Review Comments
Electrical Recommended Change Order #42
First fifteen plan sheets
{85R1,91R1,93R1,117R1,118R1,119R1,120R1,121R1,122R1,132R1, 133R1,141R1,142R1,154R1,172R1}
Michael Travis

MARK	DATE	DESCRIPTIONS	BY	CHK	CCO
A	8-06-07	Revision to misc. electric works. Clarity Interface between cable tray and conduit.	MP	EL	SO
		REVISIONS			42

DIST	COUNTY	ROUTE	KILOMETER POST TOTAL PROJECT	SHEET NO	TOTAL SHEETS
04	SF	80	13.2/13.9	172R1	1204

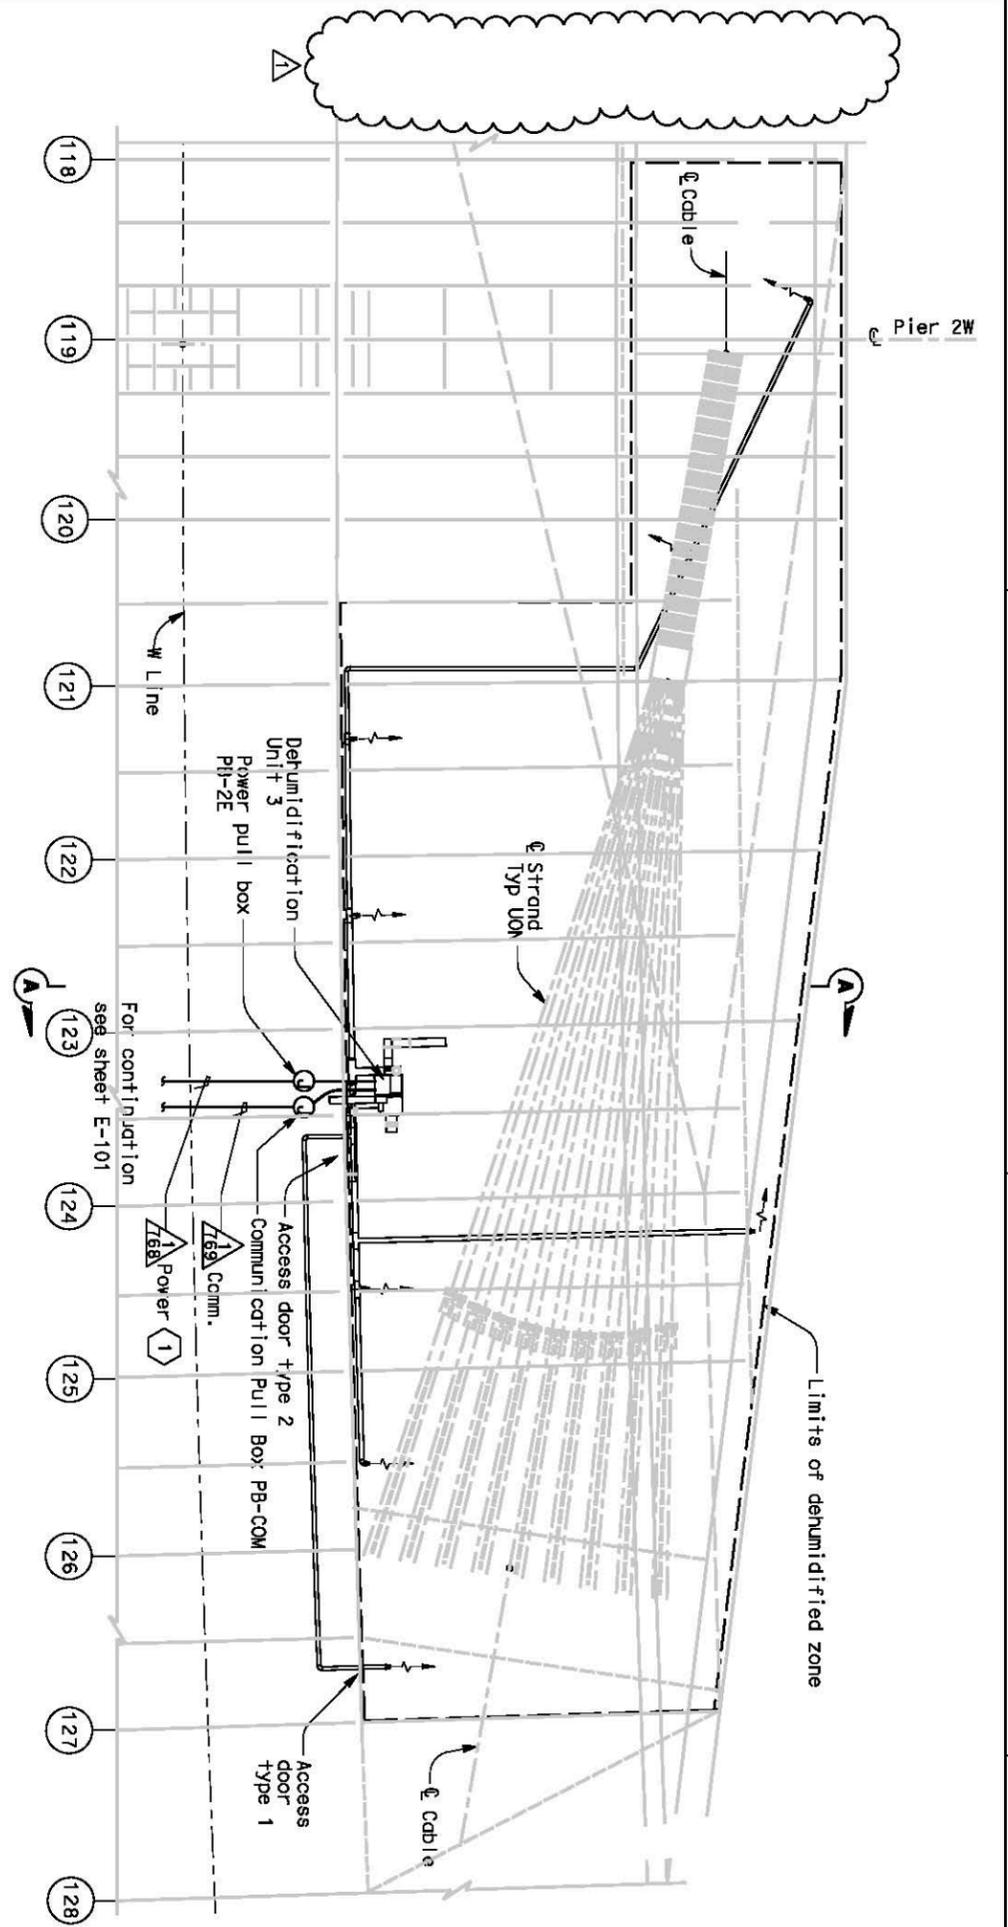
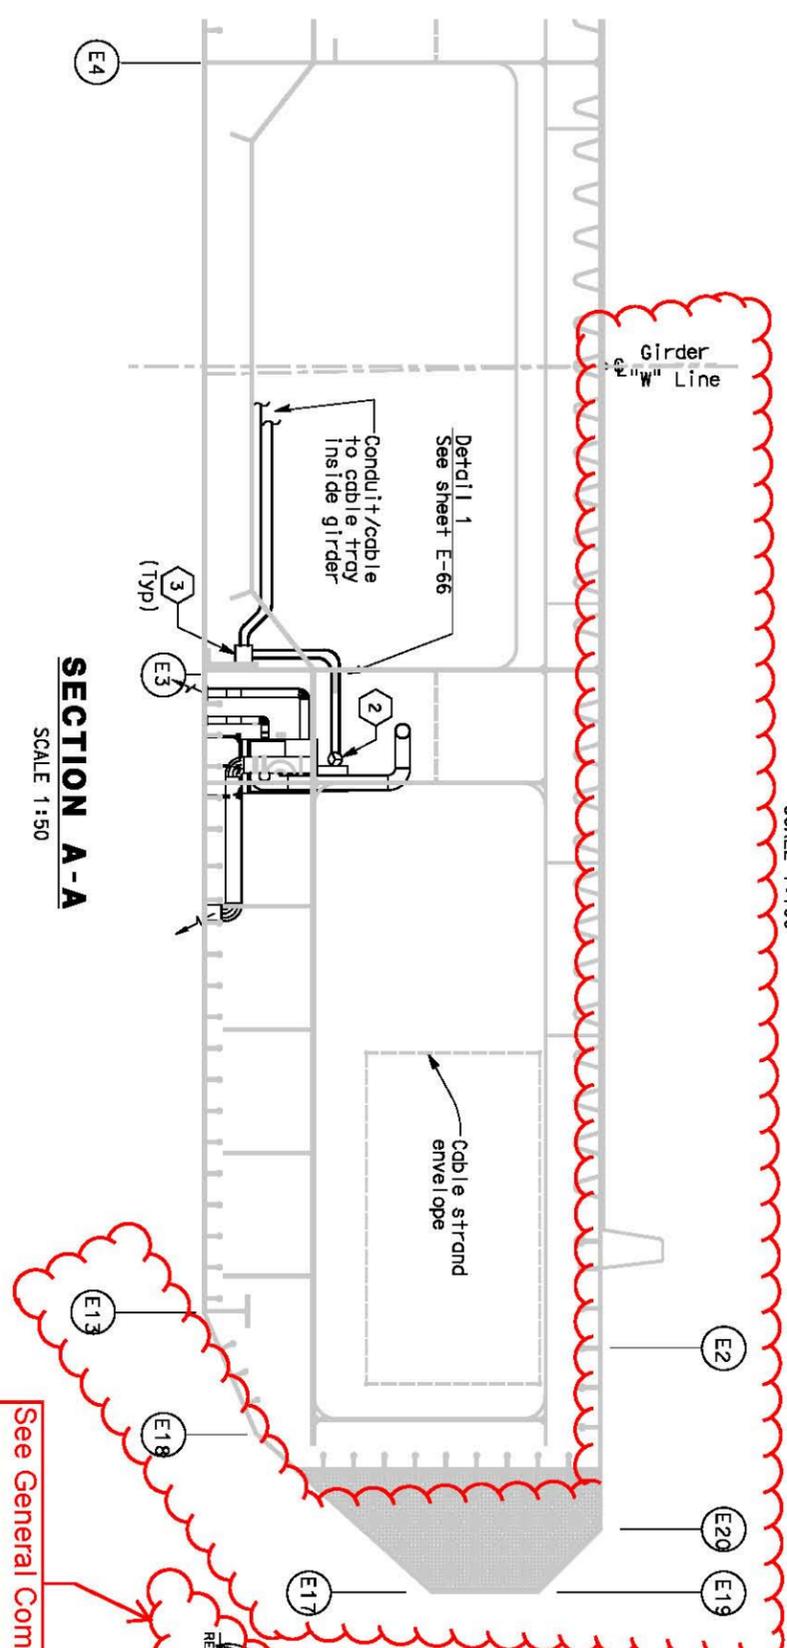
- ❖ The section A-A shows Girder center line for "W" westbound but the section cut layout and column numbers are for eastbound structure. Also there is no north arrow on the plan sheet. Need to correct this on the contract plan.
